Regulation No. 46 (Devices for indirect vision)

Proposal for a draft Supplement to the 04 series of amendments to Regulation No. 46 (Devices for indirect vision)

Submitted by the expert from the Netherlands*

The text reproduced below was prepared by the Informal Group on Camera-Monitor Systems (IGCMS-II) as a revised version of Regulation No. 46, to introduce the optional replacement of mirrors of Classes I to IV by camera-monitor systems. The modifications to the current text of Regulation No. 46 are marked in bold for new or as strikethrough for deleted characters.

Figure 7

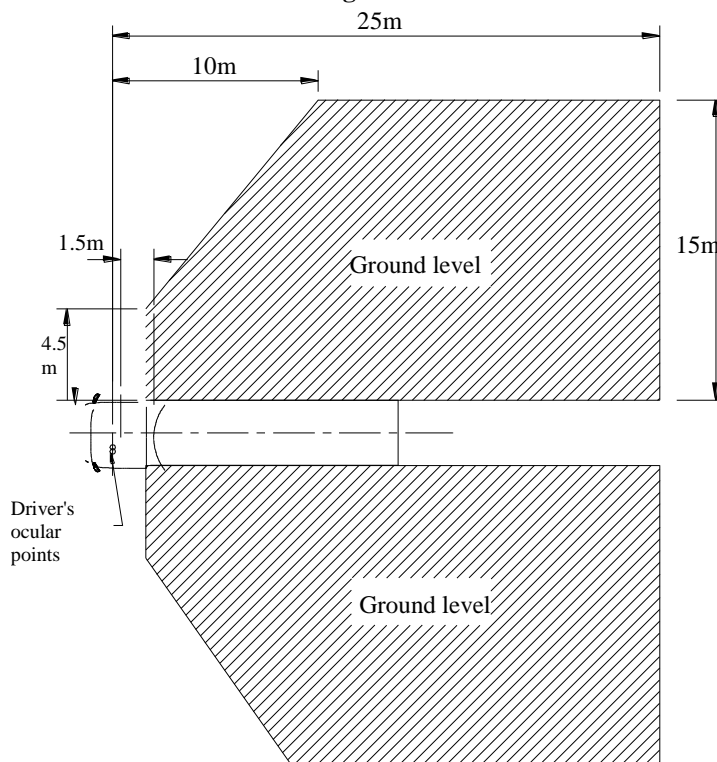
Figure 7 has been corrected on the passenger's side so that the indicated dimensions are in correspondence with the front of the grey area.
